ADDENDUM NO. 2

Date: 10 FEB 2022

SDG Project No.: 21-10

Project Name: 133 Bull Street Streetscape Enhancements

ADD2-1A
Dated 10 FEB 2022

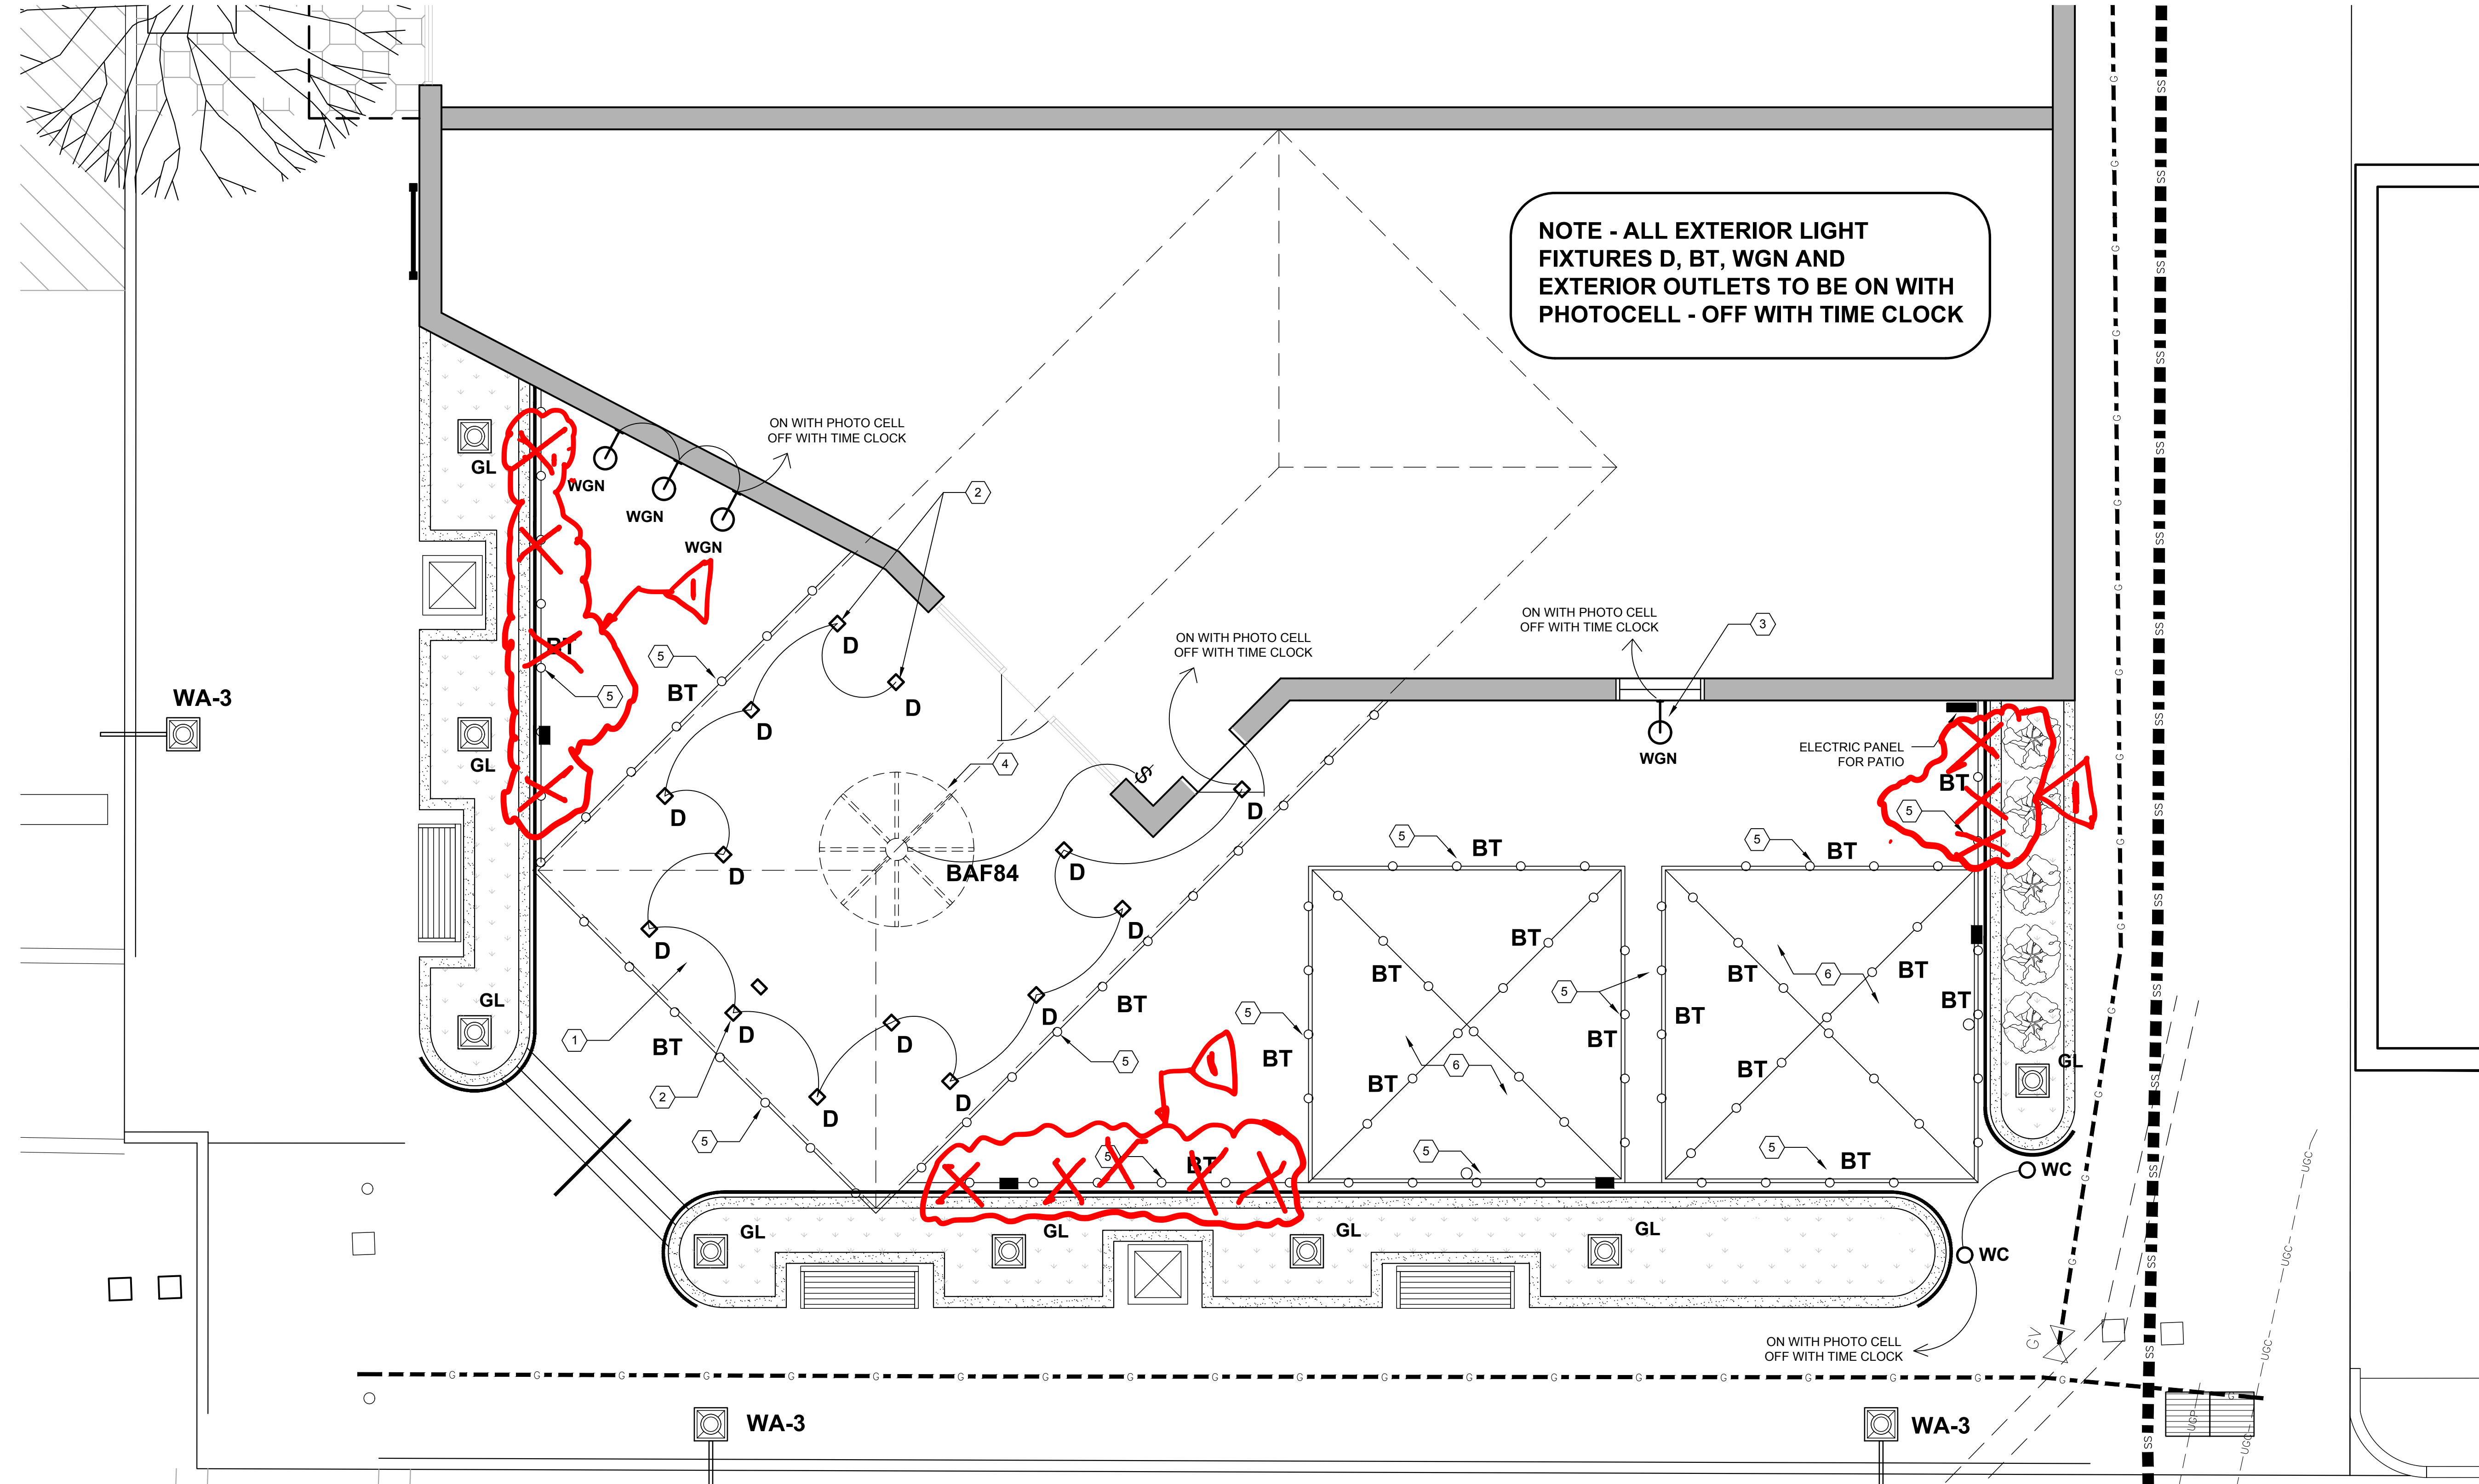
- A. See attached sheet ADD2-1A showing bistro lights to be omitted.

DATE	DESCRIPTION
10 FEB 2022	ADDENDUM NO.2 Bistro lights to be omitted
